Technical Service Bulletin (TSB)

Evap / Fuel Line Quick Connect Exposed Near Exhaust

REFERENCE:	**TSB:** 14-011-26 **GROUP:** 14 - Fuel	**Date:**	October 31, 2026	**REVISION:**	—
VEHICLES AFFECTED:	**2026 (WS) Jeep Wagoneer / Grand Wagoneer** **This bulletin applies to the vehicle built on or after April 14, 2026 (MDH 0414XX) and on or before April 18, 2026 (MDH 0418XX) equipped with 3.0L Twin Turbo Six Pack SO ESS (Sales Code EFH).**			**MARKET APPLICABILITY:** ☒ NA ☐ MEA ☐ SA ☐ IAP ☐ EE ☐ CH **NOTE: This bulletin applies to the North American market.**	
CUSTOMER SYMPTOM:	**Customers may experience a Malfunction Indicator Lamp (MIL) illumination and the vehicle may exhibit/set the following Diagnostic Trouble Code (DTC):** • P0456-00 EVAP System Small Leak.				
CAUSE:	**Exposed evap / fuel line quick disconnects**

Fig. 1
Fuel Line Quick Disconnects Location

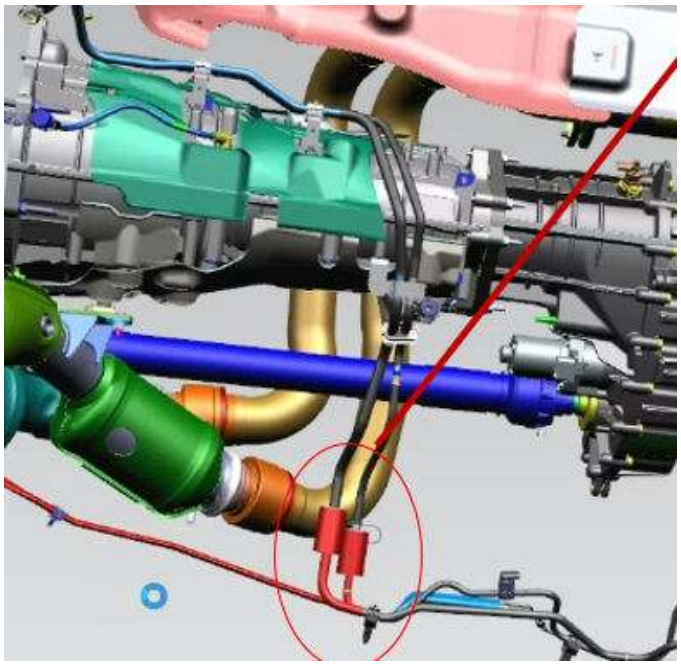
1. Raise and support the vehicle. Refer to the detailed service procedures available in DealerCONNECT/ Service Library under: Service Info> 04 - Vehicle Quick Reference / Hoisting / Standard Procedure.
2. Inspect the evap / fuel line quick disconnects Fig. 1.

Fig. 2
Fuel/Evap Line Quick Disconnects Exposed

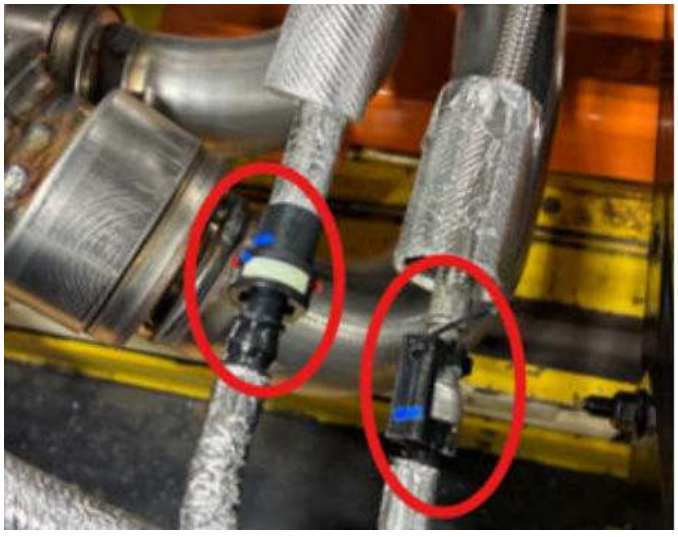
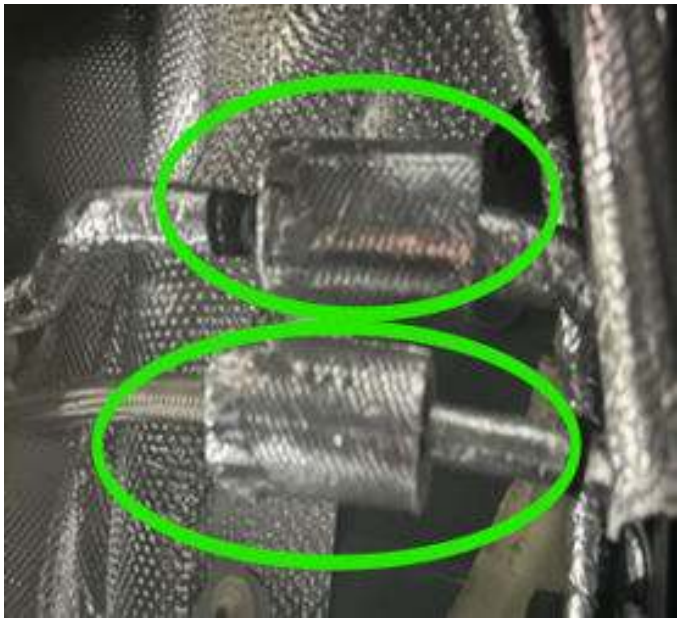
3. Are the evap / fuel line quick disconnect heat shields improperly positioned, exposing the evap / fuel line quick disconnects Fig. 2?

4. Reposition and secure the heat shields Fig. 3.
